Architectural Review Board

Meeting Minutes

April 18, 2018

ARB-13-2018 Certificate of Appropriateness

Source: Main Street Elevation from Market and Main Phase 2 submittal

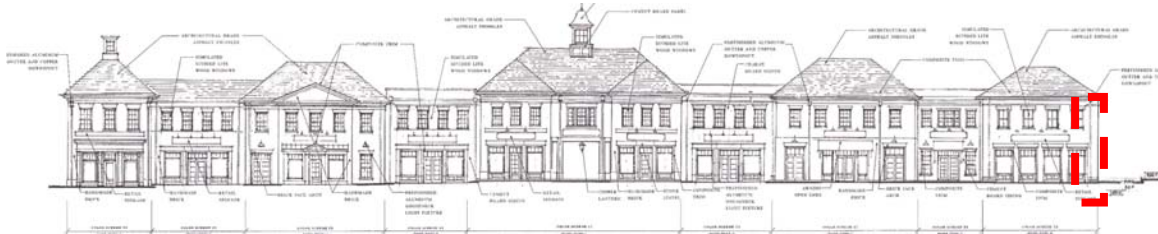
Mr. Mayer stated that the I think we are looking for the bottom of the sign aligns with the bottom of the transom. We want it lowered to make it pedestrian scale. It's a little higher than the other signs.

Mr. Hinson stated that the picture looks like the sign arm is aligned with the top of the transom.

corner, staff recommends the mounting location be modified to align the top of the sign with the top of the transom window to achieve a pedestrian scale and orientation.

1. The main arm of bracket aligns with the main arms of existing hanging signs in Market Square.
2. Lighting is subject to staff approval. Upon roll call vote: Mr. Hinson, yea; Mr. Brown, yea; Mr. Thomas, yea; Mr. Strahler, yea; Mr. Iten, yea. Yea, 5; Nay, 0; Abstain, 0; Motion carried by a 5-0 vote.

1. The mounting location is modified to align the top of the sign with the top of the transom window in order to match other existing projecting signs in the Market Square area, subject to staff approval.
